MANDATORY SERVICE BULLETIN

NUMBER: SB11-08
REVISION: 00
DATE: 06/24/2011

SUBJECT: SPAR PASS-THRU HOLE AND TAILCONE MODIFICATION

KODIAK 100 Series Aircraft Serial Numbers: 100-0001 through 100-0045.

Figure 1-1: Spar Pass-Thru Hole Modification

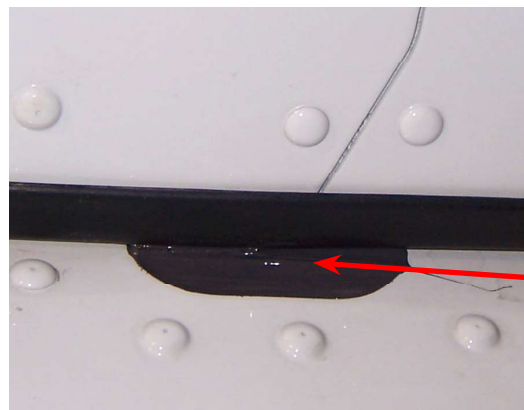
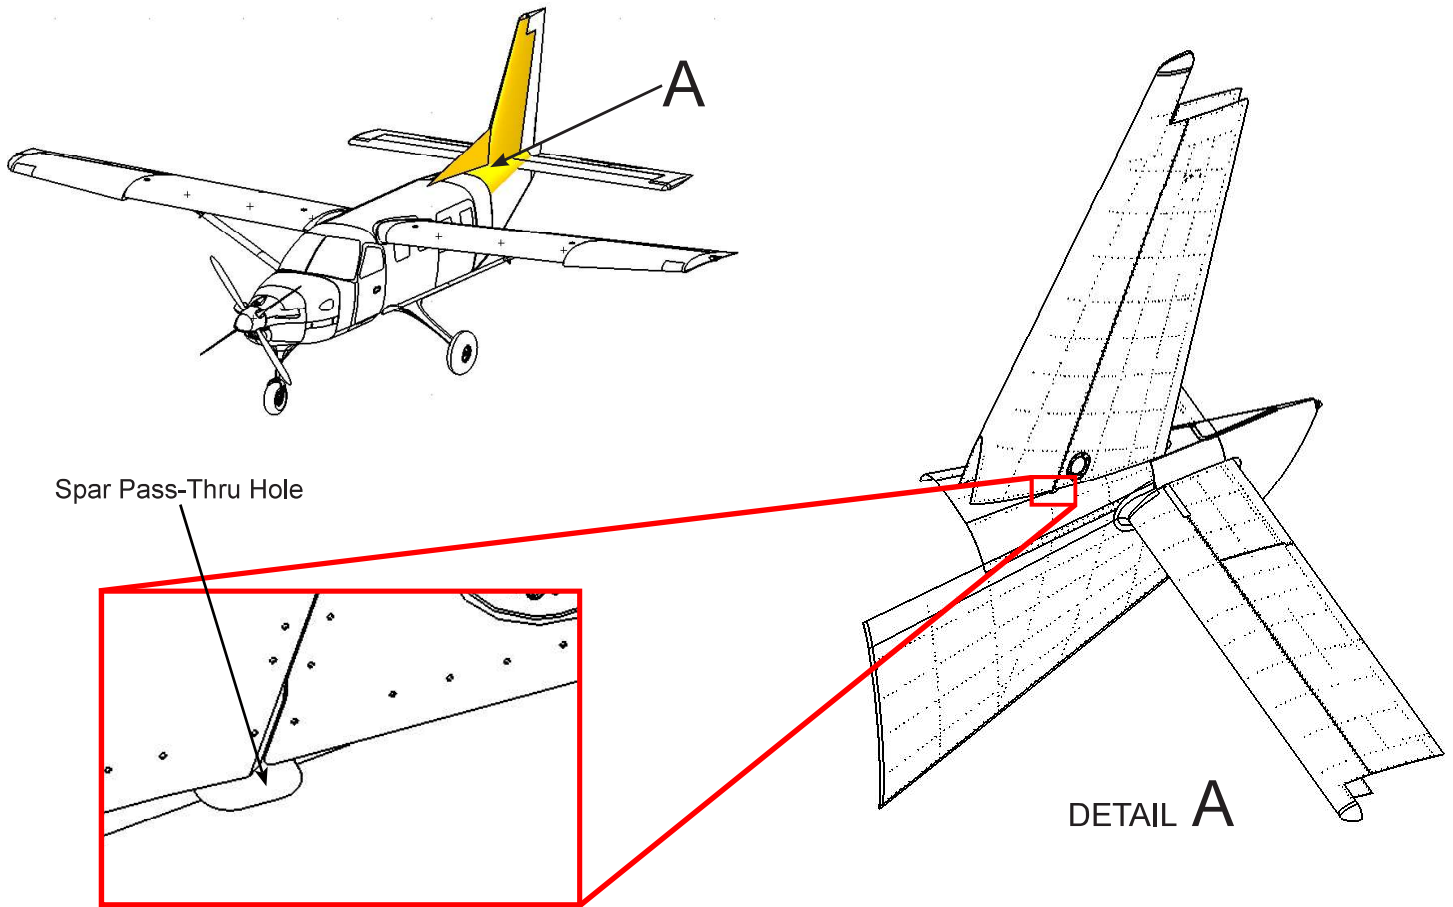
It has been determined that the mount design of the vertical tail leaves two uncovered areas in the top of the fuselage that allows fluid entry into the area AFT of the rear interior bulkhead. This fluid does not adequately drain, and has a potential to negatively affect some of the electronics.

Quest is mandating the installation of a sealant over the area indicated in **Figure 1-1**, as well as the installation of two (2) drain grommets on the underside of the tailcone.

1. Apply ProSeal® (P/N **P/S 890 B-2**) into the spar pass-thru holes shown in **Figure 1-1** on both sides of the aircraft. Ensure the sealant adheres around the perimeter of the holes and is faired to the upper surface of the aircraft skin with a 0.06" to 0.13" overlap over the edges of the hole.
2. Follow all manufacture's safety and cure time instructions.
3. Remove the masking tape applied to the inside surface of the aircraft skin.
4. Reinstall the AFT bulkhead into the aircraft as shown in the KODIAK 100 Maintenance Manual (P/N 490770).

**NOTE:** Verify that the existing X1010 edge trim on the vertical stabilizer skin is adhered to the skin and in good condition.

**NOTE:** Sealant application should be mirrored on the right side of the aircraft.

Figure 1-2: Tailcone Modification

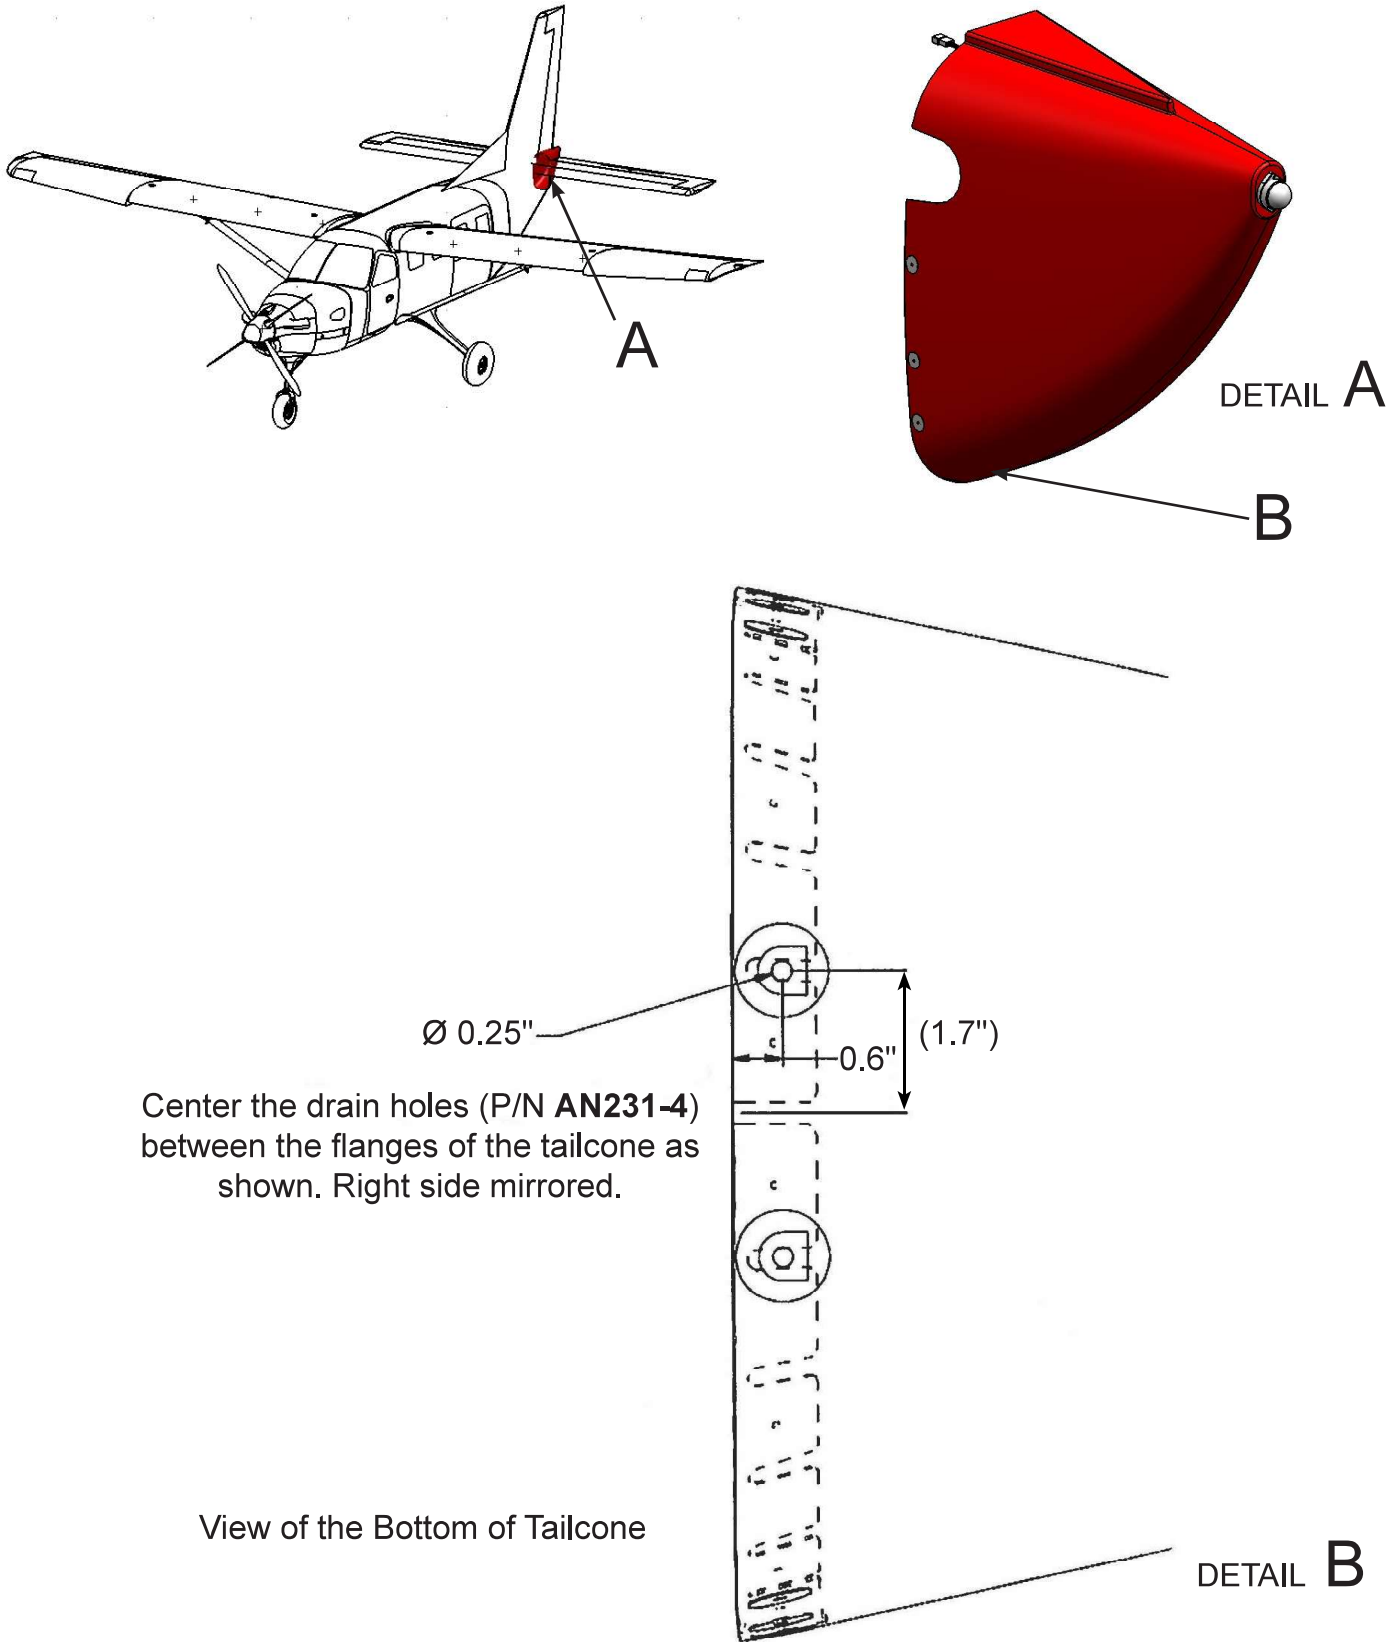
1. Remove the twenty eight (28) screws securing the tailcone (P/N **100-250-0097**) to the aft fuselage and remove the tailcone (P/N **100-250-0097**) from the aircraft.
2. Disconnect the electrical connection to the tailcone navigation light.
3. Mark and drill the drain holes as indicated in **Figure 1-2, Detail B**.
4. Apply Loctite® activator (P/N **7387**) to the bonding surfaces of the tailcone (P/N **100-250-0097**) and the two (2) drain grommets (P/N **AN231-4**).
5. Apply Loctite® adhesive (P/N **330**) and center the two (2) drain grommets (P/N **AN231-4**) over the two (2) drain holes with the exit port facing aft as shown in **Figure 1-2, Detail B**.
6. Follow manufacturer's safety and cure time instructions.
7. Position and secure the tailcone (P/N **100-250-0097**) using the twenty eight (28) screws and connect the navigation light.
